**Conservation and Water Stewardship**

**File: 5596.00**

**Re: Target Products Ltd– Notice of Alteration**

**RE: Manitoba License No. 3024 – Target Products Ltd. Notice of Alteration**

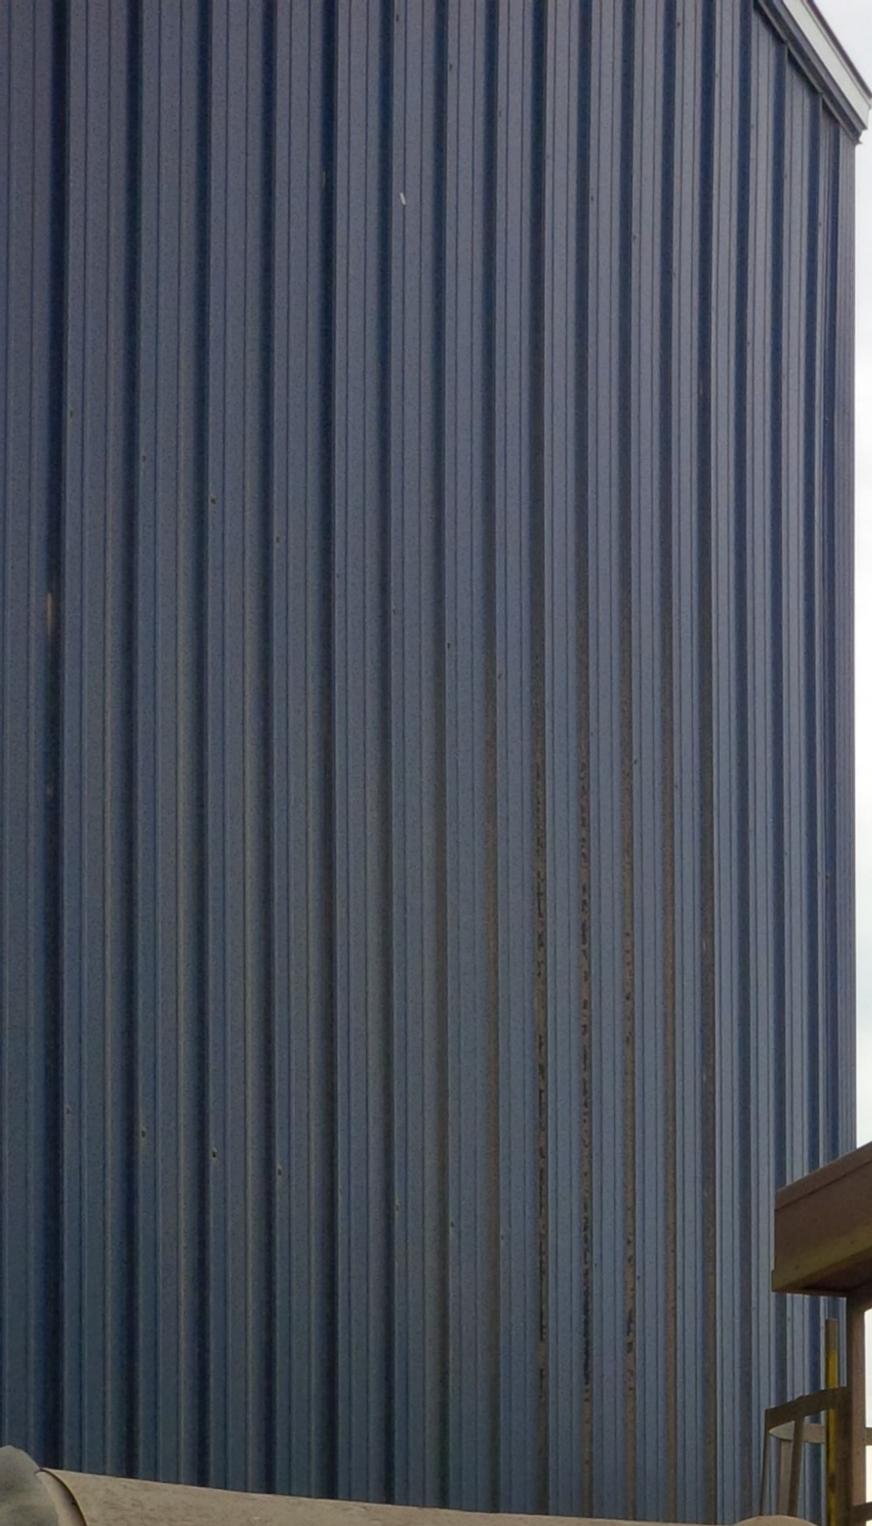
**Proposed Dryer Control Platform Weather Canopy**

The dryer control platform location is on the east side of the dryer drum. The platform is home to the burner, electrical controls, gas fittings/lines and blower mechanism for the dryer. All mechanisms are weather proof and meet Manitoba Hydro and City of Winnipeg specifications.

We propose to erect a simple metal framed canopy running the length of the dryer control platform from the burner mechanism to the end of the blower located on the east side of the dryer mechanism (approximately 7 feet from platform base and 8 feet in length). The canopy will not have any sides so as to restrict airflow through the blower or dryer intake – it simply acts as a weather guard from above and as recommended by the City of Winnipeg Fire Commissioner.

The proposed canopy will be constructed with 1.5" square steel tubing with a 20-gauge steel roofing panel.
